RE: Comments of Turner Ranch Properties, L.P. on the Draft Environmental Impact Statement for the Copper Flat Copper Mine

**COMMENTS ON THE DRAFT ENVIRONMENTAL IMPACT STATEMENT FOR THE
COPPER FLAT COPPER MINE**

**PREPARED BY THE NEW MEXICO ENVIRONMENTAL LAW CENTER (“NMELC”)
ON BEHALF OF TURNER RANCH PROPERTIES, L.P. (“TRP”)**

Figure 16: Figure 6.11 from Jones et al. (2013) showing simulated steady state groundwater contours. The red line approximately midway north/south through the map is Hwy 152. The label “simulated 2012 groundwater levels appears to be incorrect in the original document.

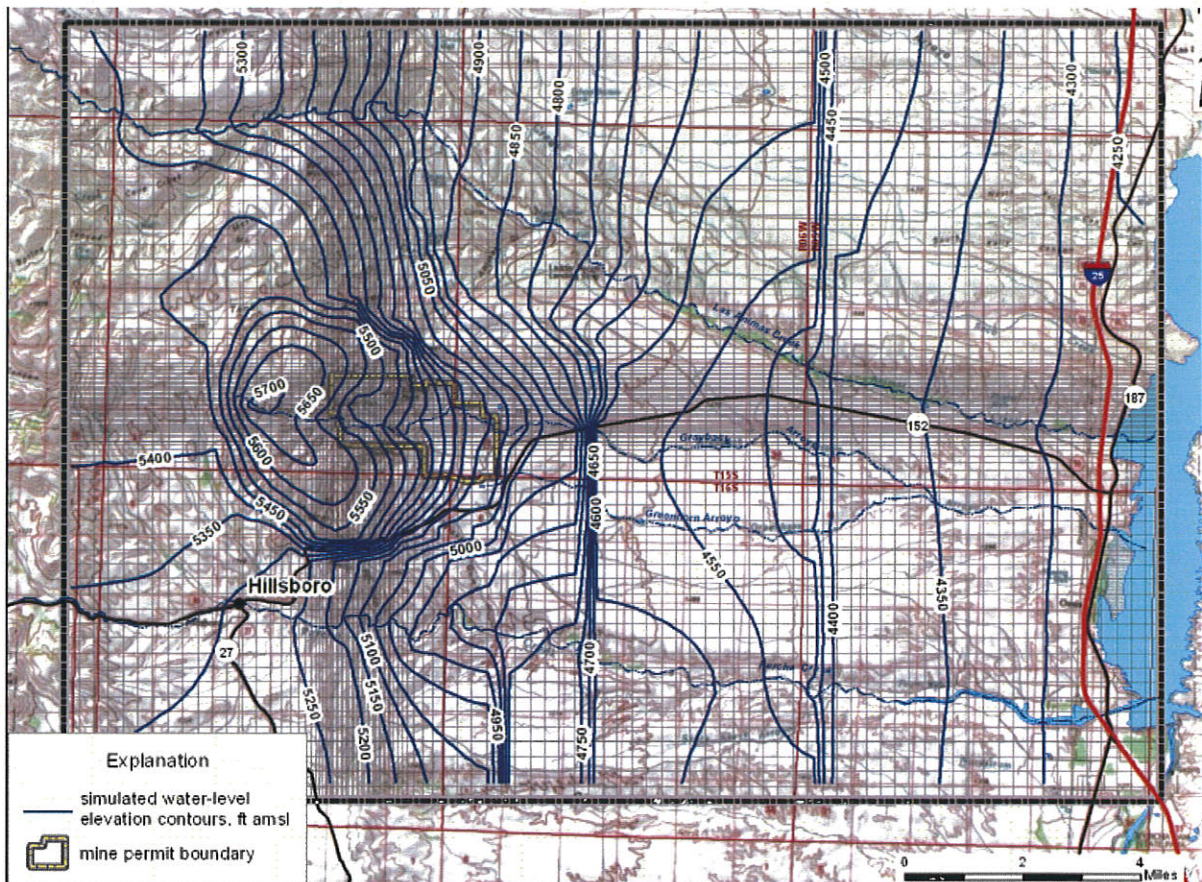
Figure 16, herein, shows the simulated steady state contours from Jones et al. (2013) Figure 6.11 (the figure is labeled "simulated 2012 groundwater levels" contrary to how the text in Jones et al. refers to it). Due to 30 years of inactivity there will not be a significant difference. Figure 9 (shown above) is the 2011 groundwater contour map from INTERA (2012) Figure 8-14. There are many differences between these two groundwater contour maps, but the most glaring difference is the lack of significant contour

drops that could be assigned to faults (Figure 14) that is at all similar to the simulated effect (Figure 16). The actual groundwater contours do not suggest the faults are barriers as conceptualized by Jones et al. (2013, 2012).

Conductance for the fault on the west side of the Palomas graben is 1×10^{-8} ft/d, while on the east side is 1, an order-of-magnitude difference of 8. The amount of water crossing the fault on the west will be miniscule and therefore the fault effectively isolates the model on the west from the model on the east. The simulated steady state contour map (Figure 16) shows two locations with significant head drops, as expected due to low conductance faults. The easternmost drop of from 150 to 200 feet coincides with fault 4 (Figure 16, see fault numbers in Figure 14), the west side of the Palomas graben. Faults 4 and 5 both have a gap at Las Animas Creek, which does not seem justified by the geology because the fault is not in the alluvial formation in layer 1. This gap will concentrate flow from west of the fault into the formation beneath the creek, where it will be available to replenish the creek or prevent drawdown.

Figure 17: Snapshot of a portion of Figure 13 in Jones (2015) showing drawdown for the 30,000 tpd scenario, end of mining.

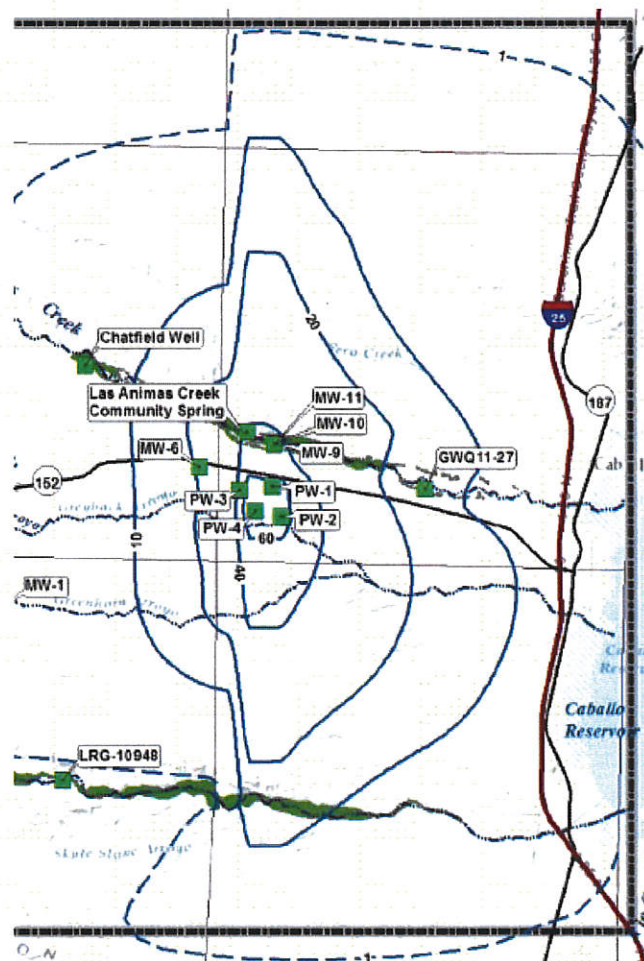
Further west, a larger drop coincides with fault 3. Just south of Hwy 152, the groundwater table drops at least 300 feet (Figure 17). However, only in layer 2 does the fault end at Hwy 152. The substantial

Figure 18: Figure 6.6 from Jones et al. (2013) showing the natural boundary conditions specified for the model simulation.

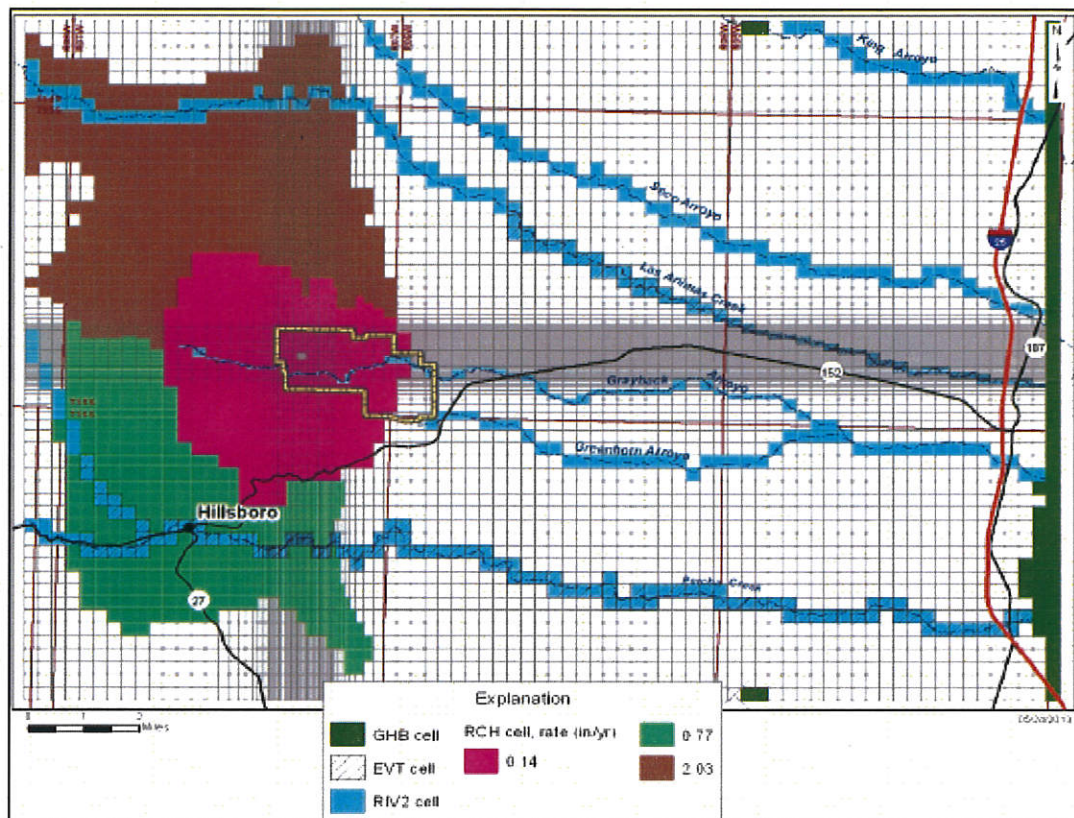
A GHB is also used to simulate the Rio Grande River and reservoir, as seen in the green cells on the east side of Figure 18, herein. The report does not specify this, but the MODFLOW input files show that this boundary occurs only in layer 1. This has the effect of driving flow from the lower to the uppermost layer, which is just 100 feet thick in this location. It also creates a backwater and higher gradient in layer 2 than would occur if the groundwater could discharge directly from layer 2 into the reservoir.

Figure 20: Figure 6.8 from Jones et al. (2013) showing modeled tailings infiltration.

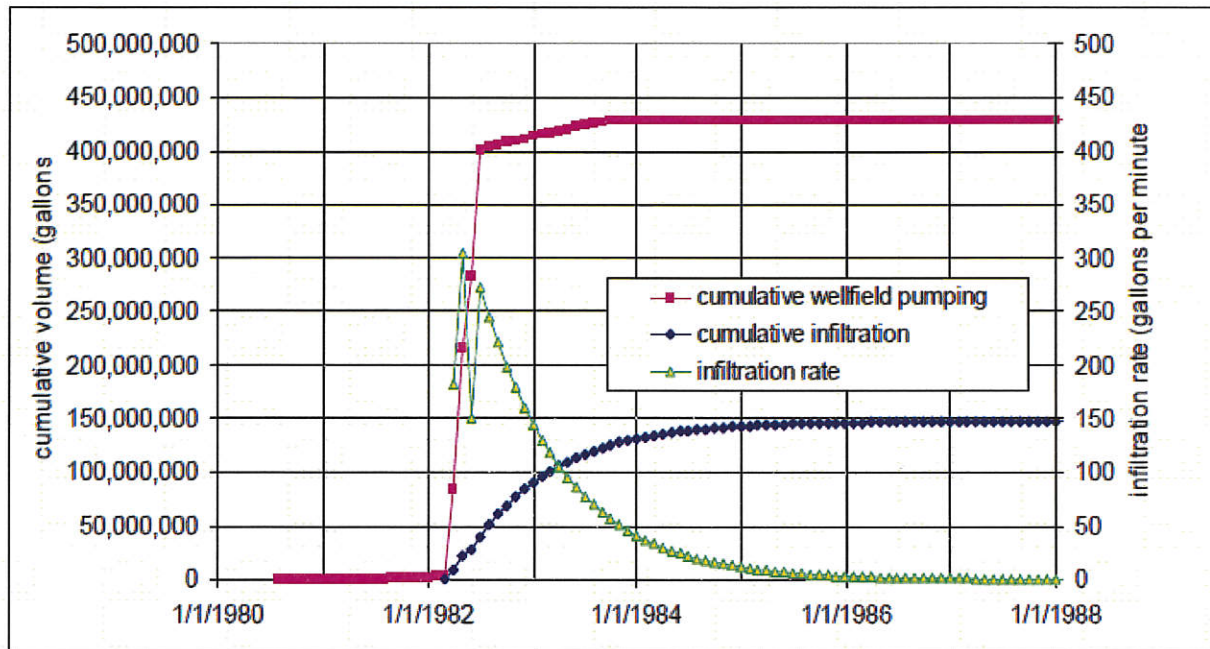
Wells NP-1 through -5 and GWQ-12 show rising water levels in response to the existing tailings seepage and the prevention of eastward flow by faults (Figures 6.22 to 6.27). All simulated responses show a steep rise during the early 1980s, when the tails were initially created, followed by a decrease in water level to at least half of the initial rise. The observed water level data decreases much less than smooth curves for the simulated water levels. This suggests that the simulated tails seepage is less than what actually occurs.

- By underestimating seepage, the model will underestimate the long-term effect of continuing seepage.

Jones et al. (2013) simulates tailings seepage using a specified flux boundary, which is a well boundary that injects a specified amount of seepage. The rate apparently is determined by calibration with a constraint being the amount of water added to the impoundment. Figure 20 herein shows the estimated infiltration rate exceeded 250 gpm briefly in 1982, and dropped close to zero by 1986, when the cumulative infiltration reached 150,000,000 gallons, or about 460 af.

Figure 21: Figures 5.14 and 5.15 from Jones et al. (2014) showing the long-term pump test results for pumping production wells PW1 and PW3.

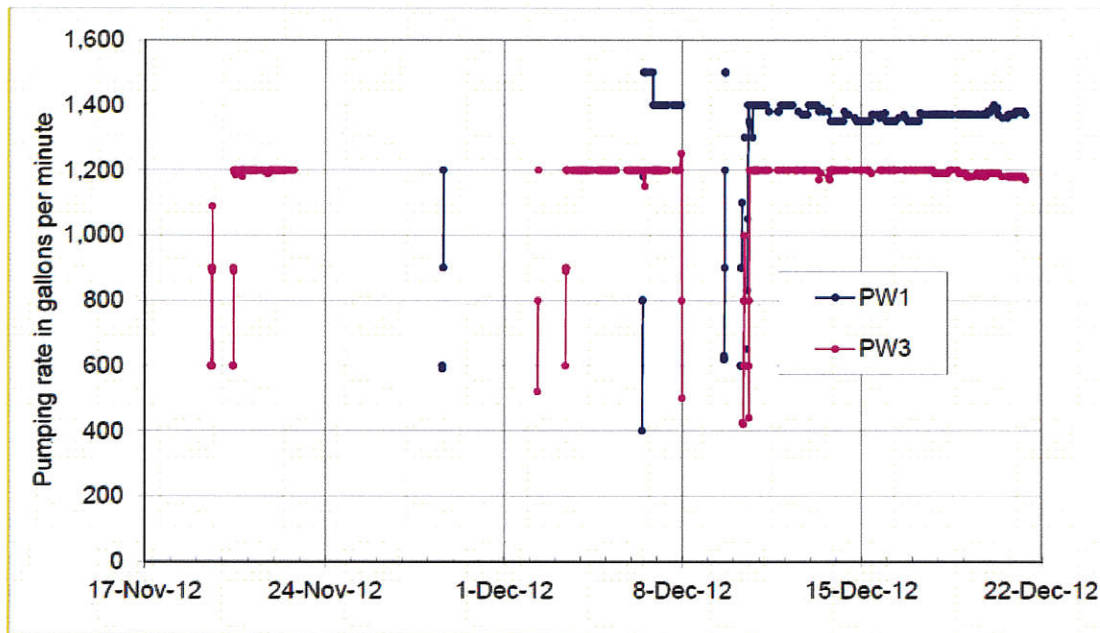
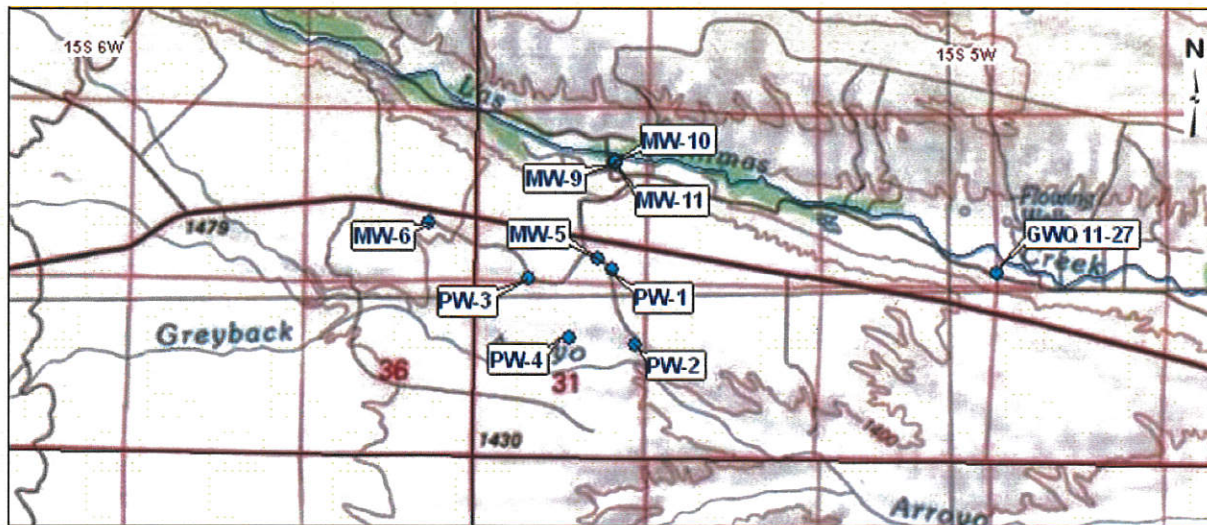
For the pumping wells, the report compares the measured, simulated, and bore simulated water level hydrograph. The bore simulated hydrograph includes estimated well bore loss, using a proprietary MODFLOW package LAK2, to estimate the free water surface within the well accounting for well bore losses. This can partially account for the differences in measured well levels because the simulated well levels are an average over the model cell rather than the actual value in the well bore. Figures 6.31 and 6.32 show substantial differences between simulated and bore simulated, and for PW-1 the bore simulated closely matches the simulated water level hydrograph, with the simulated water level hydrograph having almost 100 feet less drawdown (Figure 6.31). The observed water level hydrograph shows almost 40 feet more drawdown than the bore simulated for well PW-3 by the end of pumping. PW-3 is pumped successfully for longer periods than is PW-1 (Figure 21), and because observed matches bore simulated initially (Figure 6.32), the model may provide more water more easily to PW-3 than the aquifer will during production pumping. The calibrated parameters may underestimate the drawdown at PW-3.
